Your Ref
WA/19/15/HH
Our Ref
PLAN-009749
Date
14/05/2015

Proposal: Demolition of existing garage & construction of replacement garage.
Site: Larchfield, Wandleys Lane, Walberton, BN18 0QR.
WA/19/15/HH

Southern Water MapGuide Browser

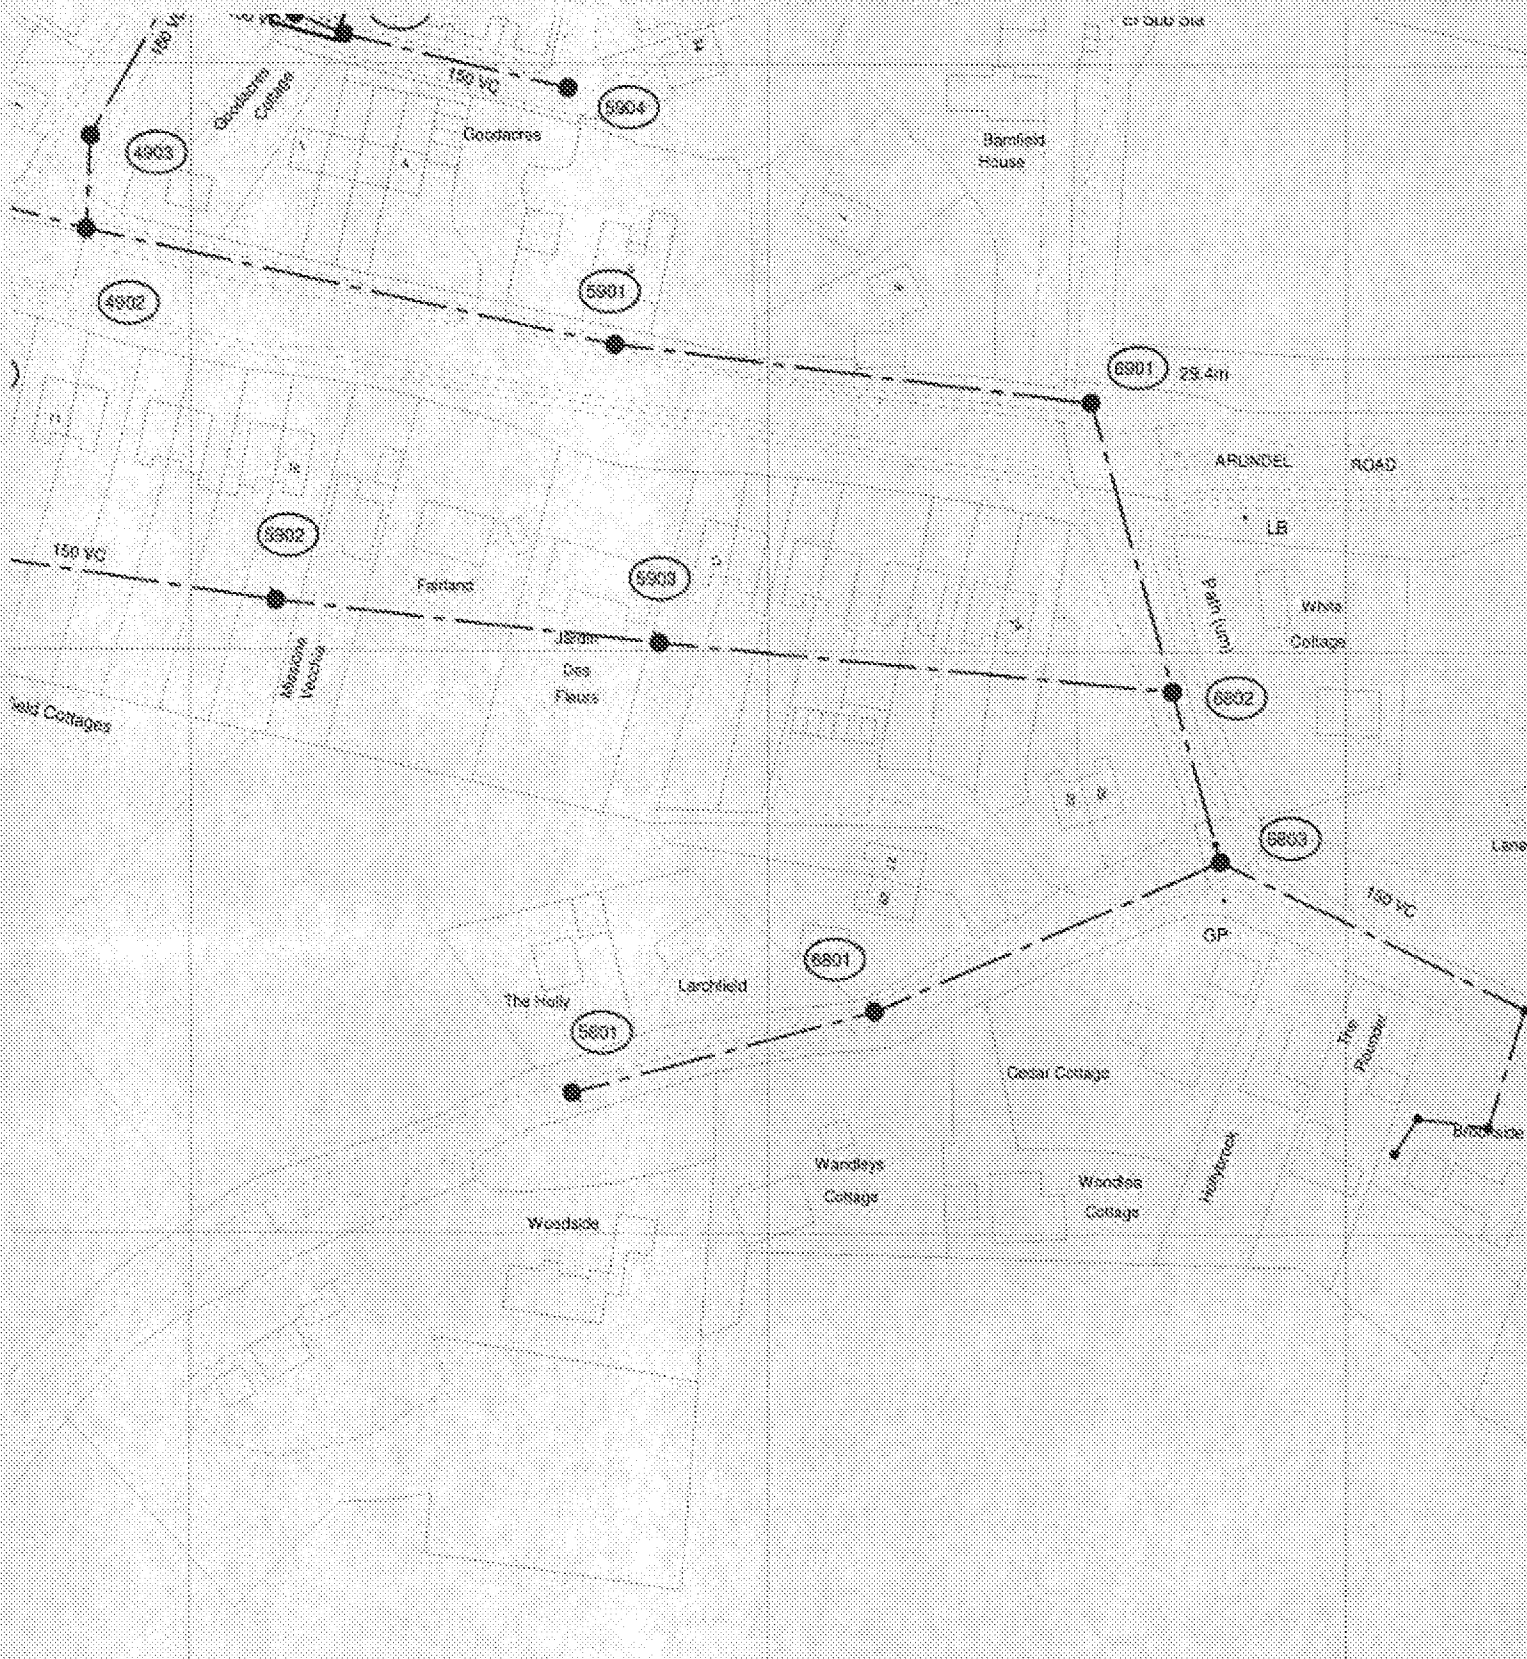
Due to changes in legislation that came in to force on 1st October 2011 regarding the future ownership of sewers it is possible that a sewer now deemed to be public could be crossing the above property. Therefore, should any sewer be found during construction works, an investigation of the sewer will be required to ascertain its condition, the number of properties served, and potential means of access before any further works commence on site. The applicant is advised to discuss the matter further with Southern Water, Sparrowgrove House, Sparrowgrove, Otterbourne, Hampshire SO21 2SW (Tel: 0330 303 0119) or www.southernwater.co.uk.
